**WARRANTY
 BULLETIN**

Wb03-23

DATE : NOVEMBER 2003	SECTION :	18 - Body
EXPIRATION: NOVEMBER 2005		
SUBJECT: VERIFICATION OF RADIATOR DOOR AND ENGINE COMPARTMENT CURB-SIDE DOOR LATCH MECHANISM

FIGURE 2: STRIKE-PLATE

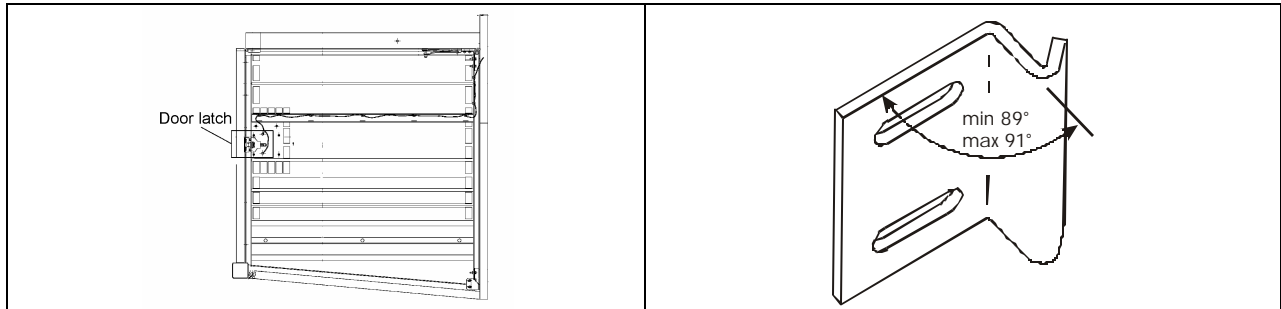
On the above mentioned vehicles, there is a risk that the radiator door opens while the vehicle is traveling. This is due to a wrong bending of the strike-plate. It is necessary to check the strike-plate bending and if needed, to replace it.

1. Open the radiator. Check for the proper bending of the strike-plate (figure 2). The angle must be at $90^{\circ} \pm 1^{\circ}$. If the angle is different from that specification, replace the strike-plate. Do the same verification for the engine compartment curb-side door.

Note: Check that the door latch retains the door closed securely. Pull the door to open it without actuating the latch lever. If the door opens, the strike-plate has to be replaced.

Part No.	Description	Qty
287286	Strike-plate	1 or 2 as required

FIGURE 3: LATCH BOLT STROKE VERIFICATION. IDENTIFICATION OF COMPONENTS

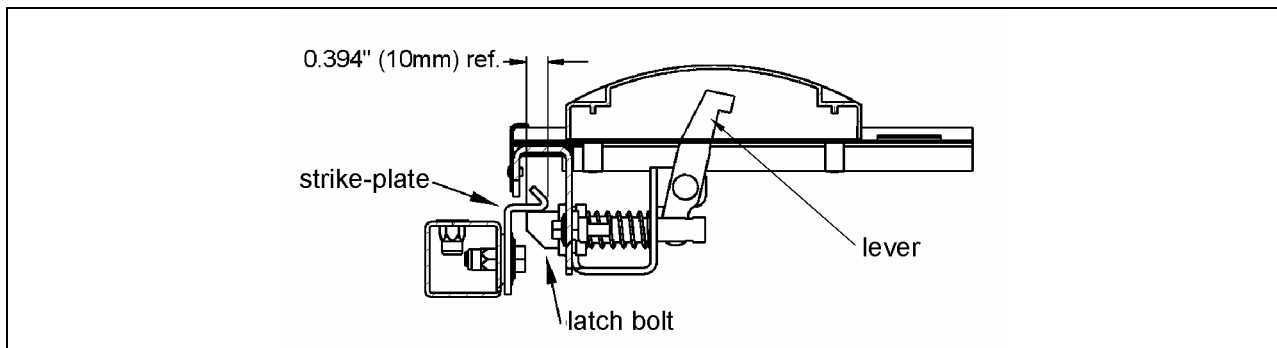
2. With the radiator door closed, actuate the door latch lever to open it. Check if there is friction or obstruction between the latch bolt and the strike plate. If the door is difficult to open, it is necessary to replace the latch mechanism by a new one that allows a longer latch bolt stroke. To do so, contact Mrs. Josyane Cote from the after-sales service at (418) 831-5432#247.

Note : To maintain the door closed securely, the latch bolt must engage 0.394" (10mm) behind the strike-plate. The latch bolt must clear completely the strike-plate to permit easy opening of the door.
